RA8M1 Group

Evaluation Kit for RA8M1 Microcontroller Group
EK-RA8M1 v1
Errata

Renesas RA Family
RA8 Series

Figure 1. SparkFun® Qwiic Connector SCL and SDA Pins

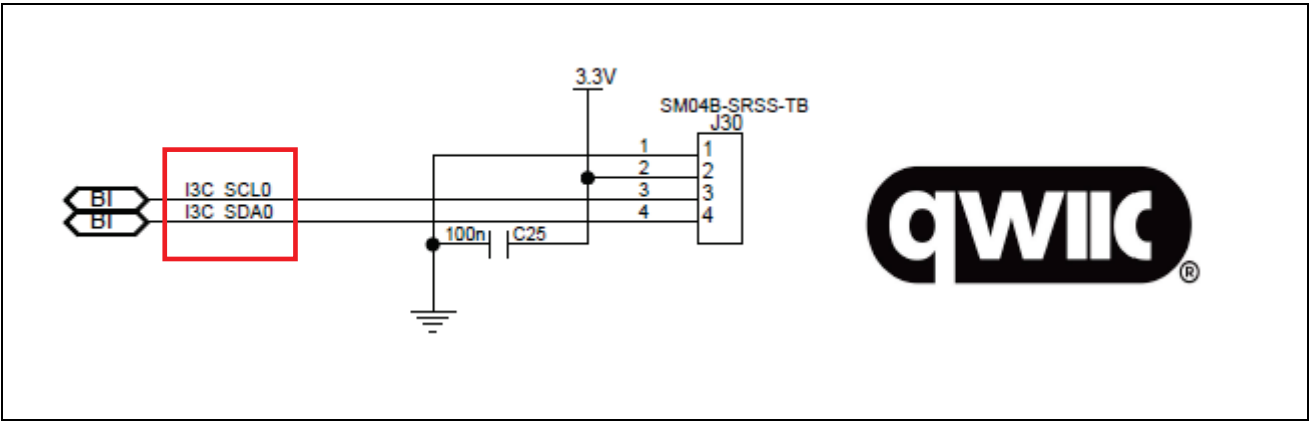
The SparkFun® Qwiic connector (J30) on the EK-RA8M1 has incorrectly transposed SCL and SDA pins as compared to the SparkFun® Qwiic definition.

The error appears in section 5.3.2 SparkFun® Qwiic Connector of the *EK-RA8M1 Hardware User’s Manual r20ut5149g0100_ek-ra8m1.pdf* and is also reflected in the schematic.

Qwiic Connector		EK-RA8M1
Pin	Description	Signal/Bus
J30-1	GND	GND
J30-2	VCC	+3.3 V
J30-3	I3C_SCL*	P400 (SCL0)
J30-4	I3C_SDA*	P401 (SDA0)

*Transposed pins.

Please manage the connection swap by modifying the cable.

None. The SCL and SDA pins will be correctly assigned in later versions of the kit.
